**TOWN OF NEWBURGH
PLANNING BOARD
TECHNICAL REVIEW COMMENTS**

PROJECT: NEWBURGH TOWNE CENTER (COFINANCE INC.)
PROJECT NO.: 19-04
PROJECT LOCATION: SECTION 60, BLOCK 3, LOT 29.11
REVIEW DATE: 26 FEBRUARY 2019
MEETING DATE: 2 JANUARY 2020
PROJECT REPRESENTATIVE: MASER CONSULTING

SPLIT RAIL FENCE GATE

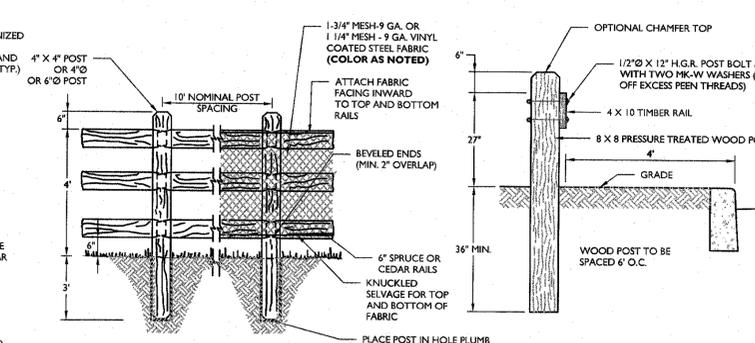
4. Health Department approval for the water system with hydrants is required.
5. An SWPPP has been submitted and was under review by this office.
6. A split rail fence detail has been added to the plans. It is unclear where the split rail fence will be located.
